**ENVIRONMENTAL CONSERVATION BOARD AGENDA**

**JANUARY 6, 2022 – 7:30 P.M.**

**Re: ECB Wetlands Permit Fatmir Osmanaj**  
**441 Barrett Hill Road,**  
**Carmel (T), Mahopac Hamlet**

**2 WETLAND CROSSING DETAILED VIEW**  
SCALE 1"=10'

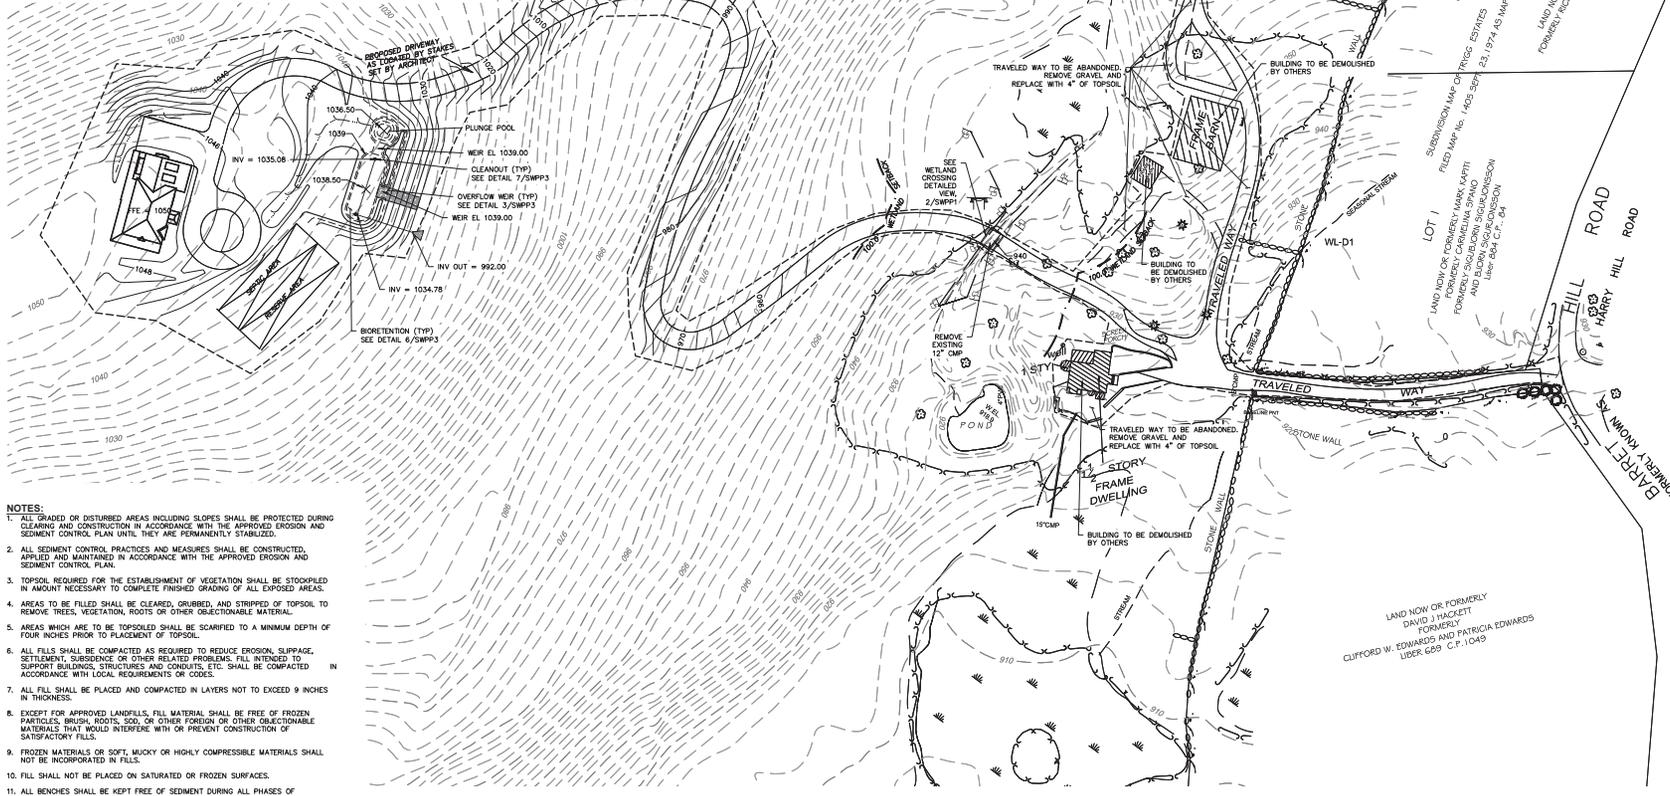
4. Maintaining stream and wetland continuity is essential to protecting these valuable resources and allowing unrestricted movement of fish and wildlife. The Department recommends a crossing be sized with the appropriate diameter culvert, or preferable, a bottomless culvert or bridge spanning the stream/wetland. What is the proposed justification for proposing one, 12-inch HDPE pipe at this location? Is the proposed 12-inch pipe adequately sized for this area?

5. Please provide a detail of the proposed HDPE pipe. What is the size of the existing CMP?

**Response: The pipe has been upsized to 18". A streamstats report has been attached and shows that this location has a peak flow of 21.8 cfs for the 100-year storm. Using the manning's equation, an 18" pipe at 5% has the capacity to convey 25.44 cfs.**

**Response: A detail for the proposed HDPE pipe and trench is provided. The existing 12" CMP is labeled to be removed on Sheet SWPP 1.**

SWPP  
3 OF 5

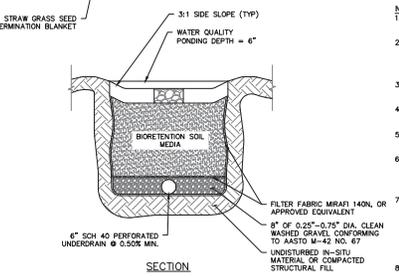
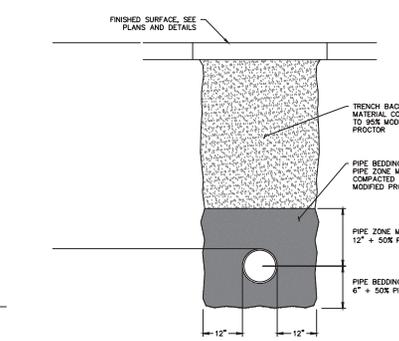
9. The Joint Application Form references a Construction Sequence, yet this cannot be located in the PDFs which were sent. Please submit. Moving forward, please note it is helpful for our review to contain an application to one combined PDF document.

10. The project area is located within screening distance of a known occurrence of the State-listed threatened northern long-eared bat. While the Joint Application Form submitted said that tree cutting is not occurring, the project area looks forested and tree clearing appears needed to facilitate the proposed residence/driveway. Please both clarify the amount of tree clearing taking place, and please note that all tree removal for this project should occur within the acceptable window, November 1 to March 31, to avoid potential impacts to this species. This would be stipulated as a condition of any permit issued for this property. If any tree removal is proposed outside this window, further review from DEC Wildlife staff would be required. Please confirm whether tree clearing would take place during this window. The construction sequence referenced should be revised, if necessary, to reflect tree cutting and the time of year which it would take place.

**Response: Comment noted. Construction Sequence Notes are provided on Sheet SWPP 3 of 5.**

**Response: Tree clearing will be minimal as the driveway follows an existing path. The construction sequencing notes on Sheet SWPP 3 specify the allowable tree clearing window.**
